# PREX Magnetic Modeling

work done by Jay Benesch

# Septum beam pipe

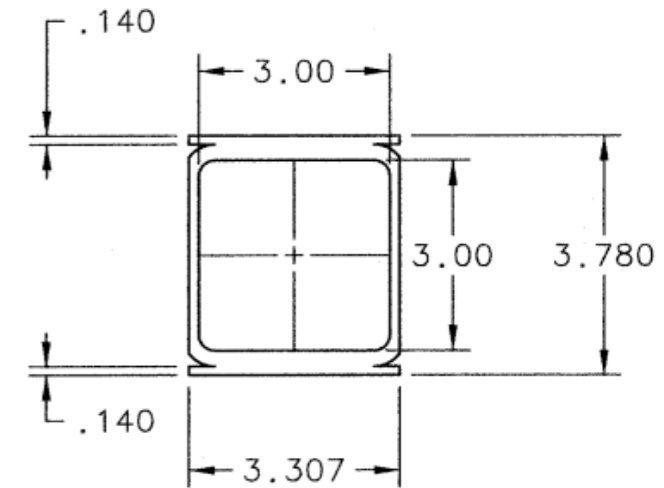
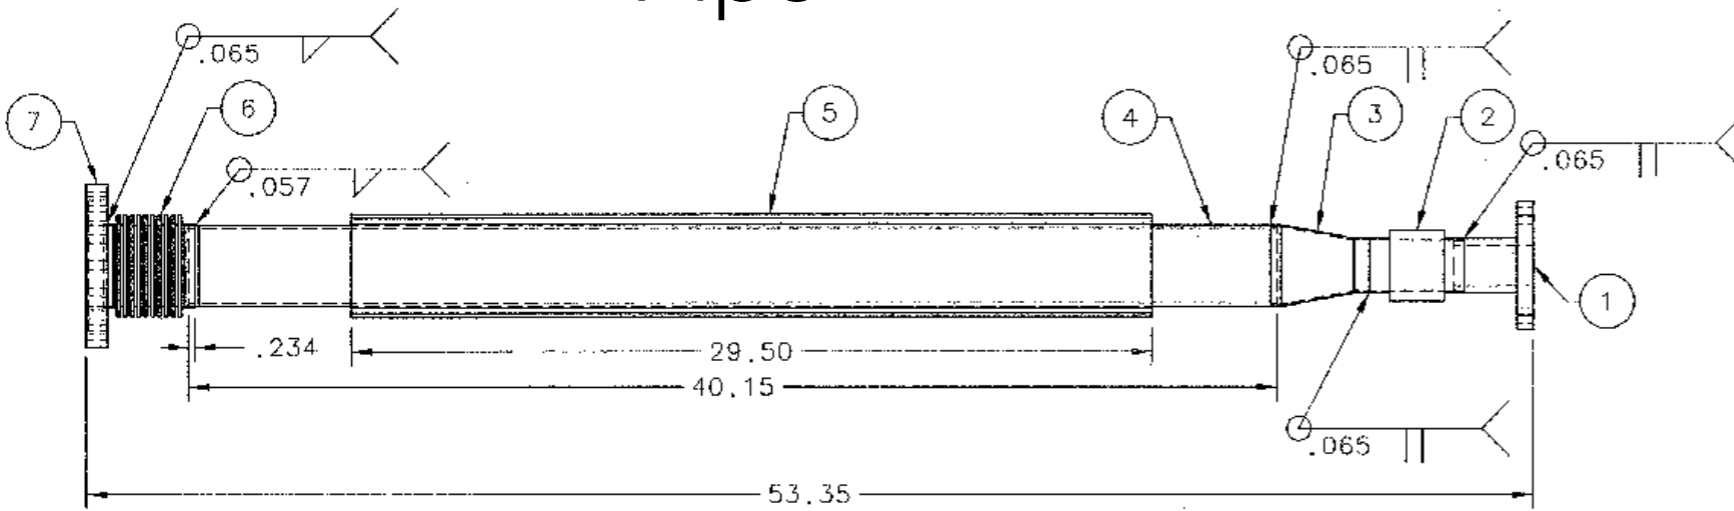
- Jay started working with the model Juliette and Iris provided
- The beam pipe through the septum in the configuration that ran for PREX1 (and is available now) has:
  - The shielding (# 5) is in actuality longer - 43.5"
  - The shielding box is made out of carbon steel and the openings at the top and bottom are filled in with weld
  - The pipe itself is made out of stainless steel

# B fringe field from current setup

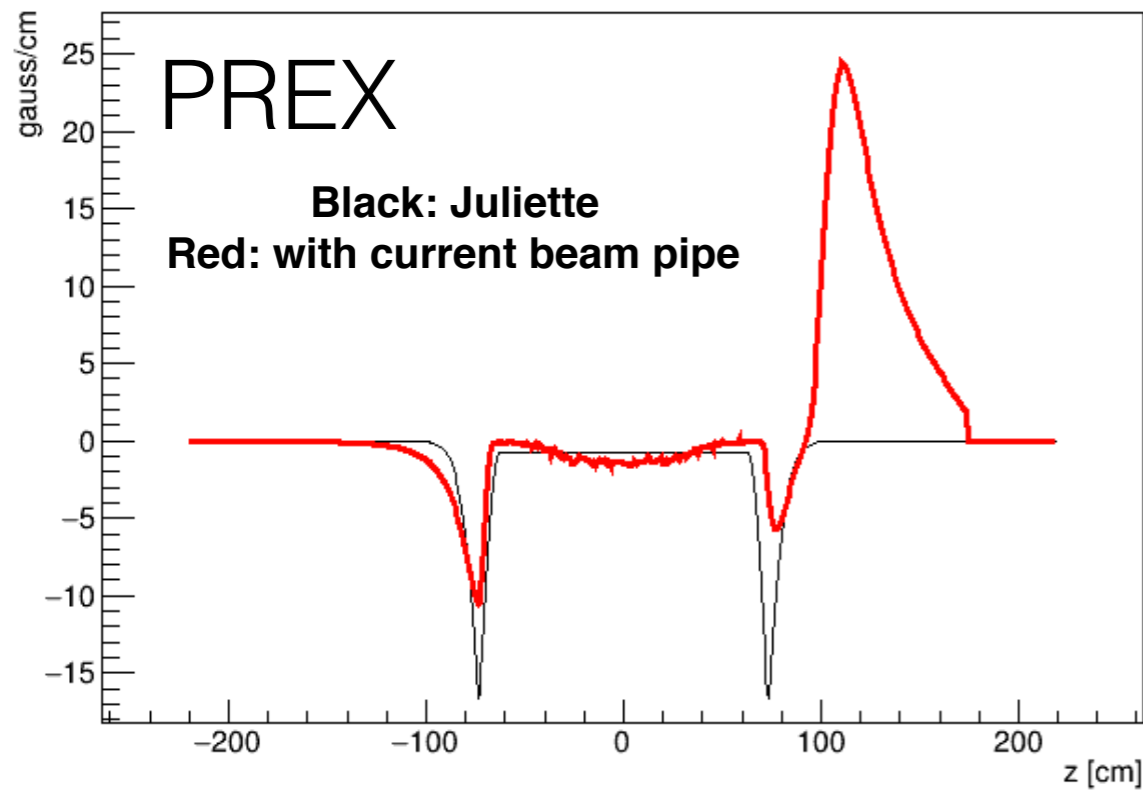
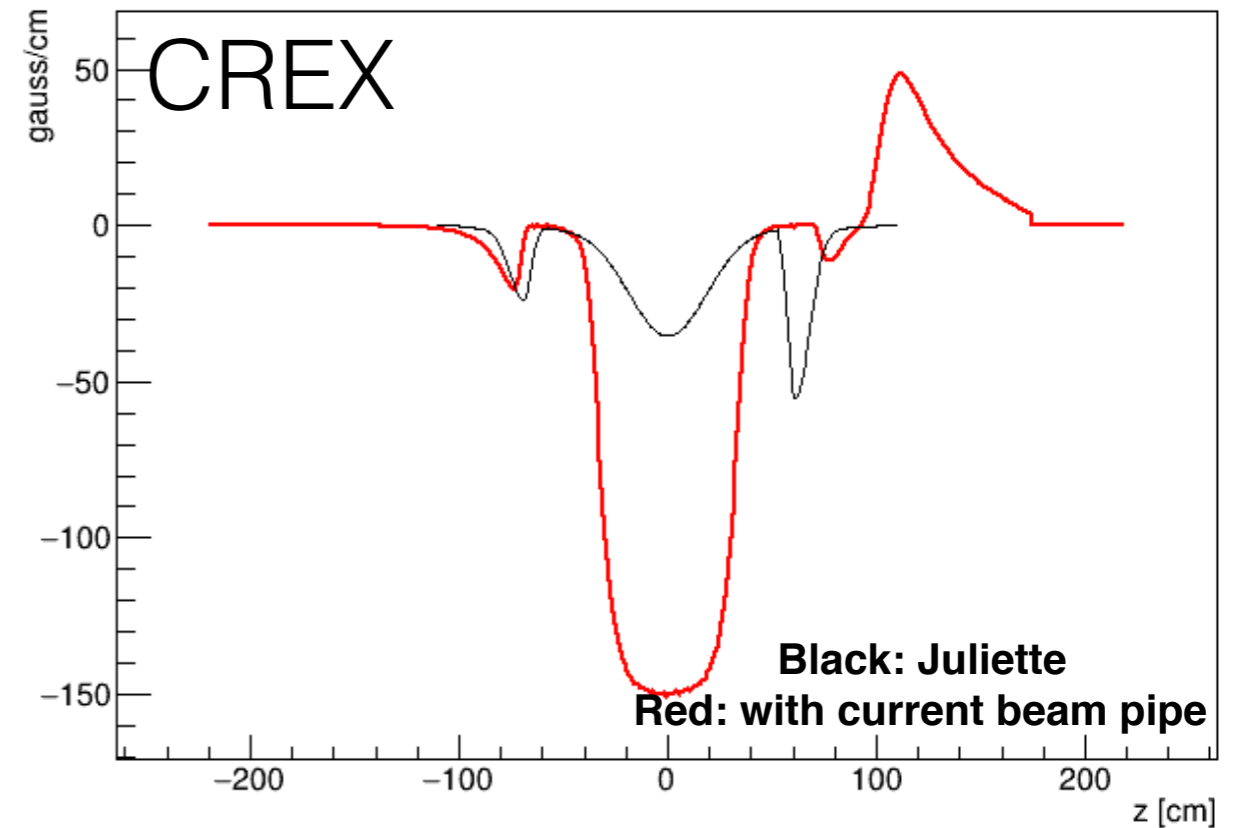
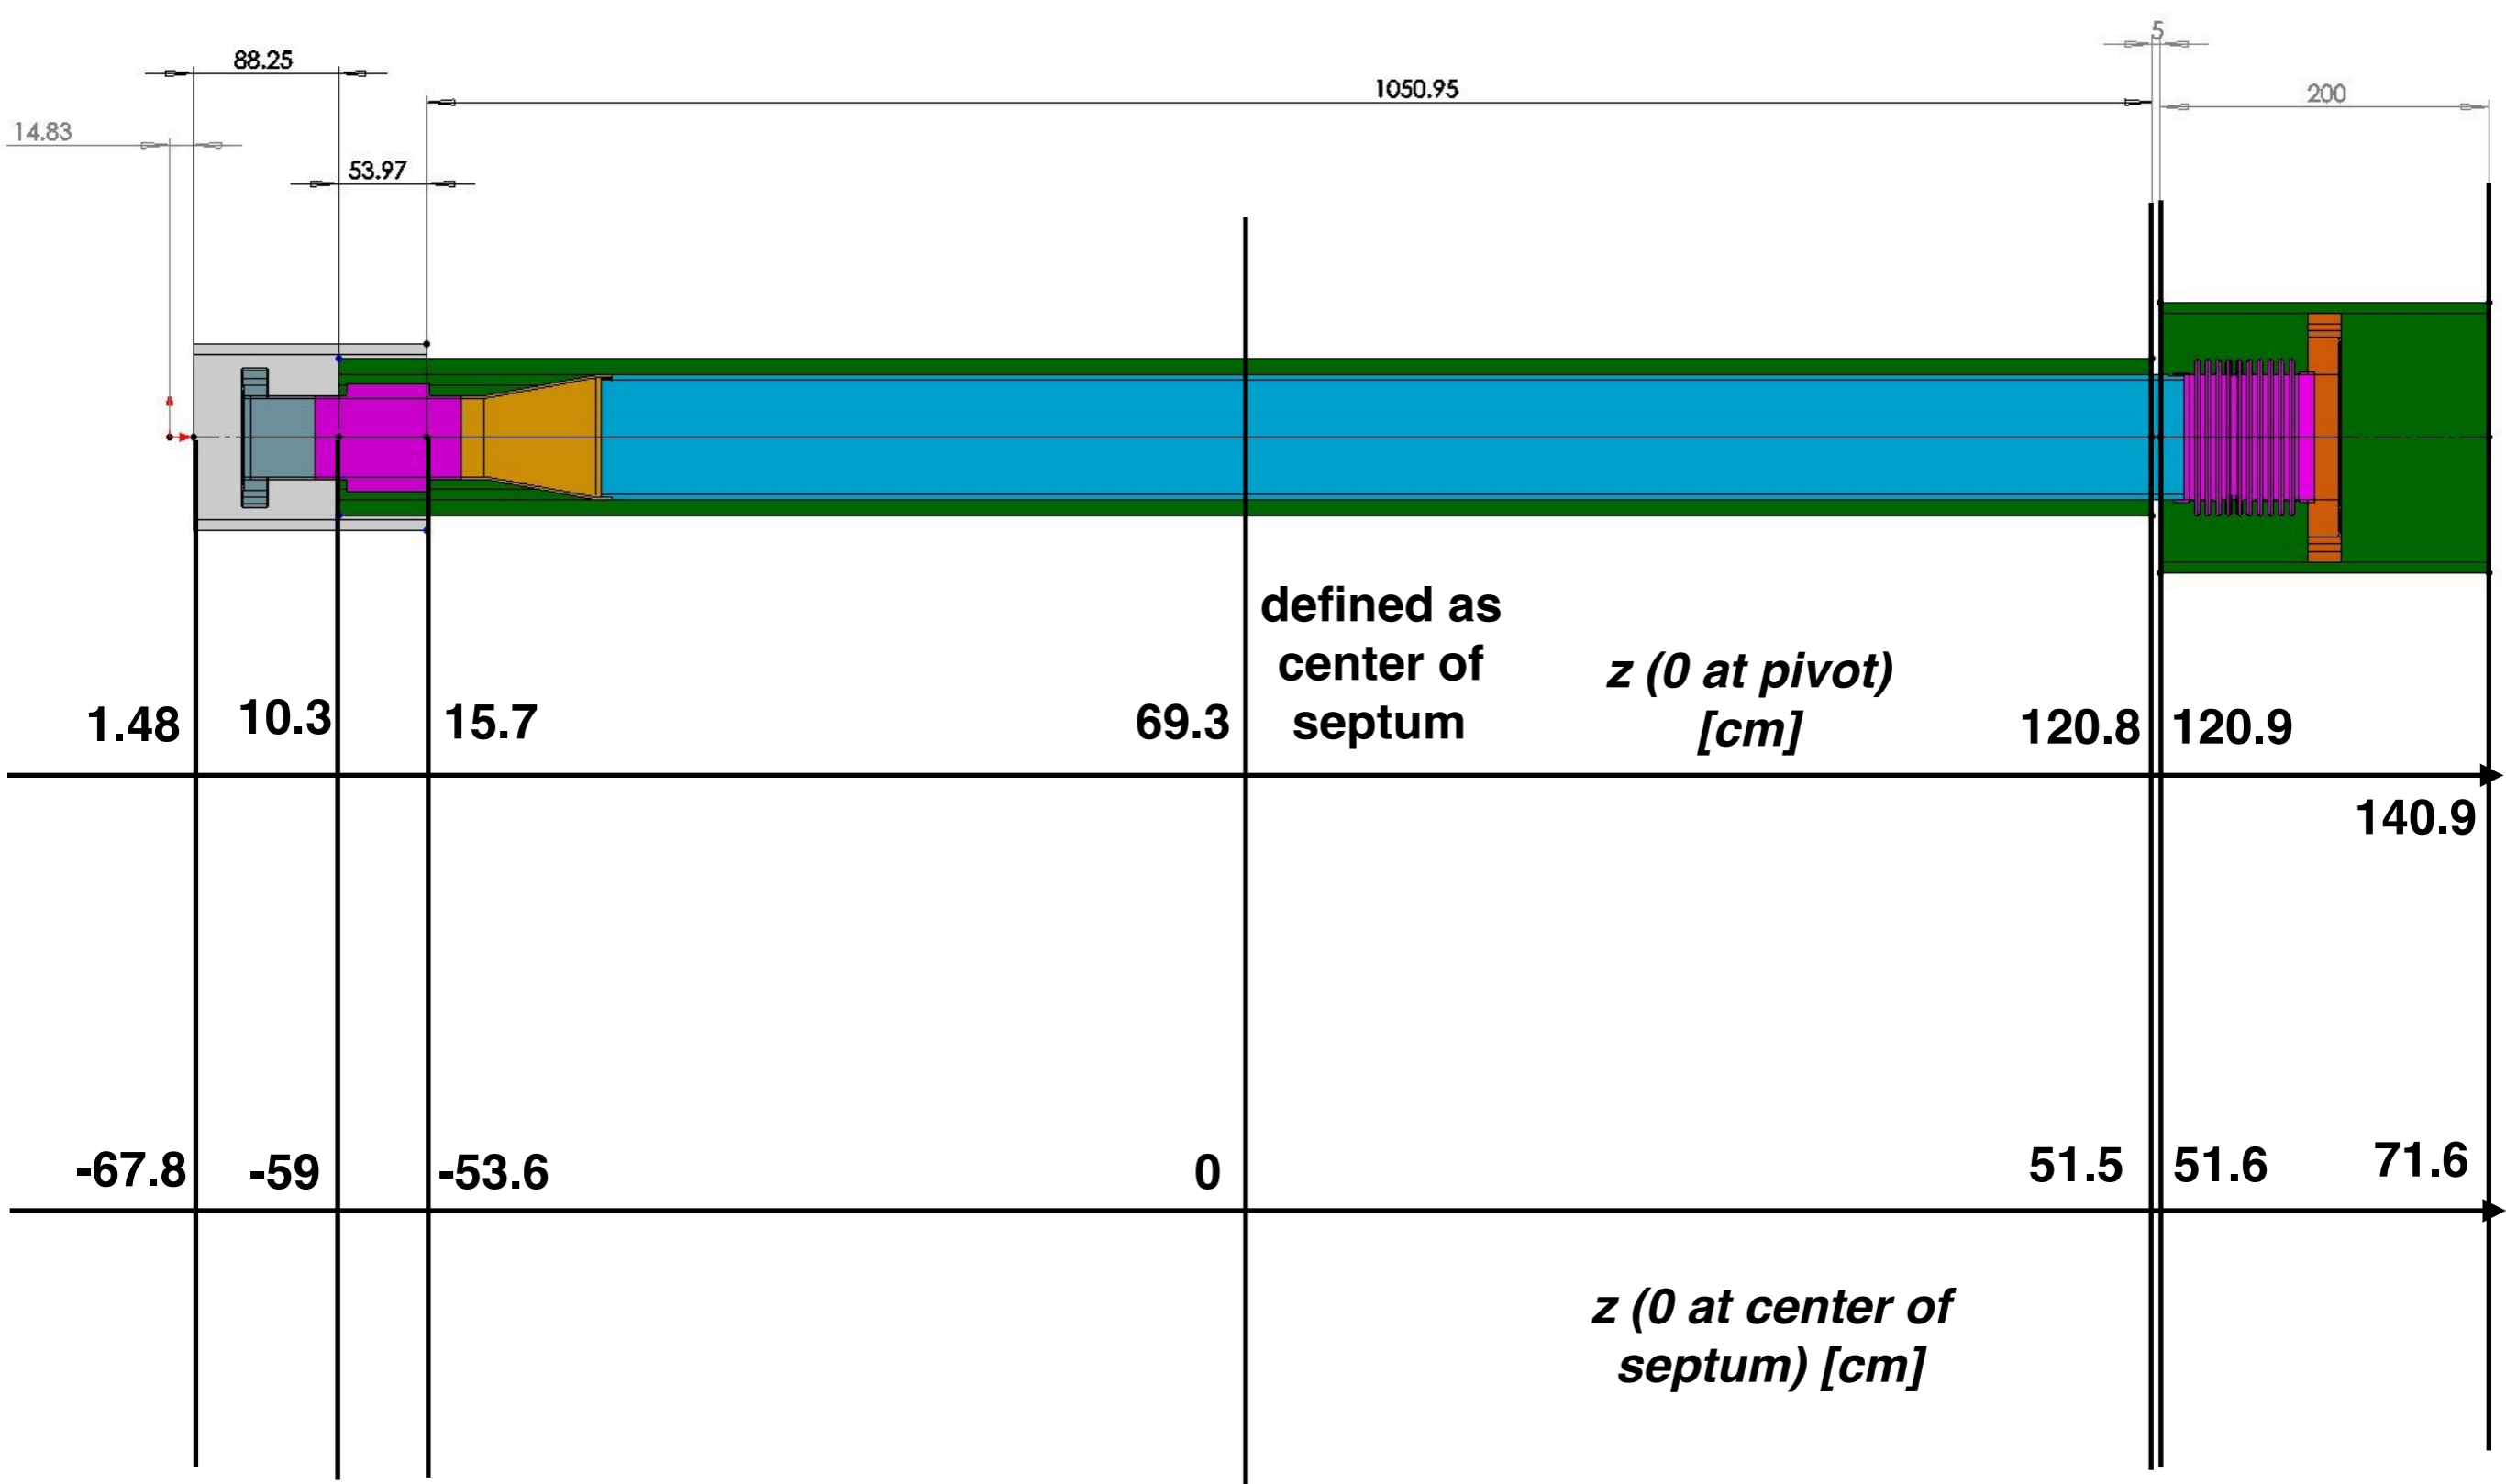
- Note that Juliette never got a fringe field for the Q1s
- The fringe field in the CREX case is probably unmanageable (radiation wise) if we keep the current setup
- Juliette must have already replaced the stainless steel pipe in her simulation with carbon-steel
- Jay has models running now with updated configuration

- Minimal changes:
  - the beampipe 3"OD 0.124" thickness should be **carbon-steel** Z[-53.6, 51.6]. The rest should be left out because that is where we will have stainless steel bellows.
  - the rectangular carbon-steel box around the beampipe should extend Z[-59, 51.6] — already in place
  - the US carbon-steel plates with 0.25" thickness should extend between Z[-67.8, -53.6] — **have to be designed and manufactured**
  - the DS carbon-steel plates with 0.25" thickness should extend between Z[51.6, 71.6] — **have to be designed and manufactured**
- Alternative solution:
  - Take two carbon steel rectangular cross section beams (of the correct size) and drill a semi-circular cavity
  - Weld the two pieces together and connect to bellows at either end

# Dipole field along signal particle path

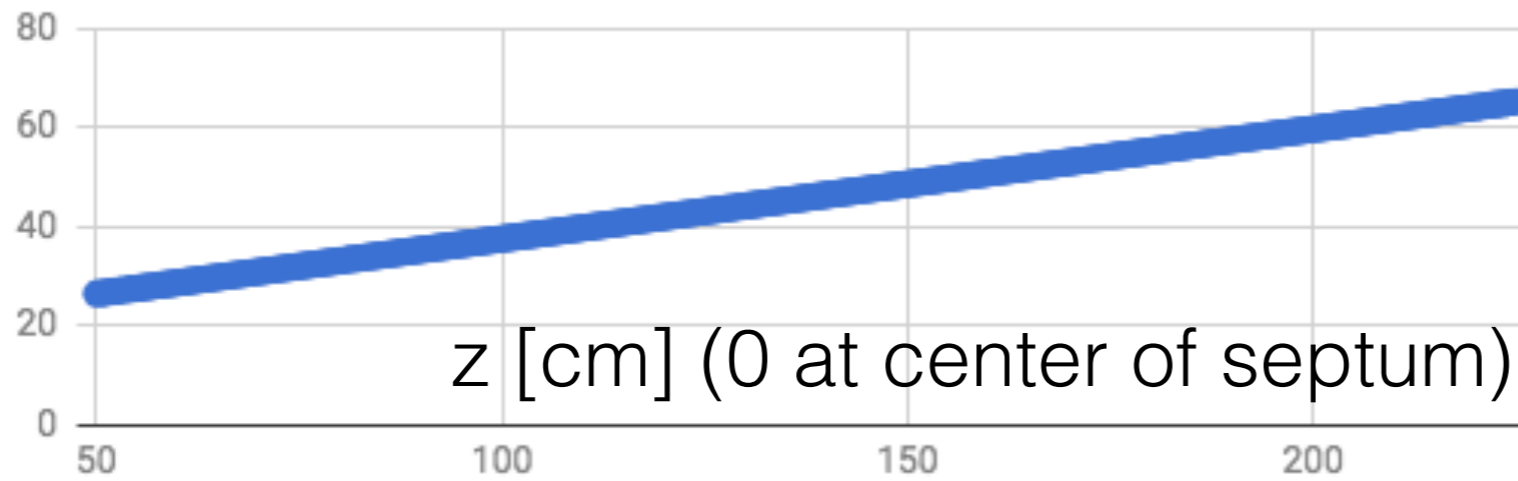
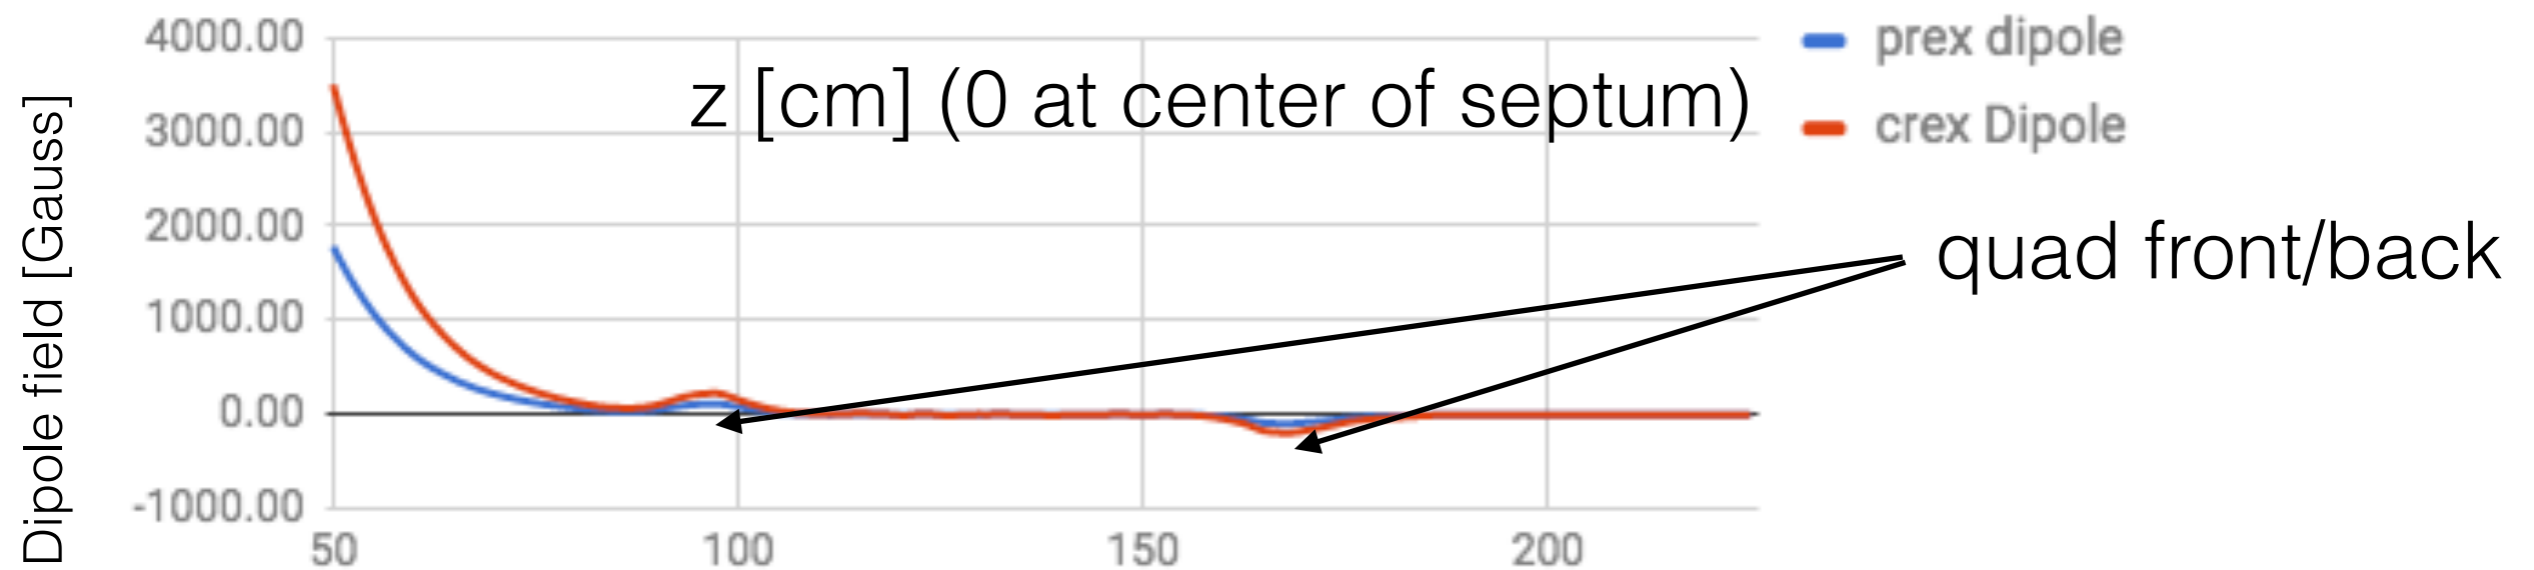
- Jay's calculations show that there is a significant dipole field along the path of the particles being scattered into the HRS
- These are calculations made by Jay and provided to us in a spreadsheet of multipoles (the large
- These are with the updated septum beam pipe (the field around 50 is due to the fringe of the septum interacting with the iron in the Q1)s
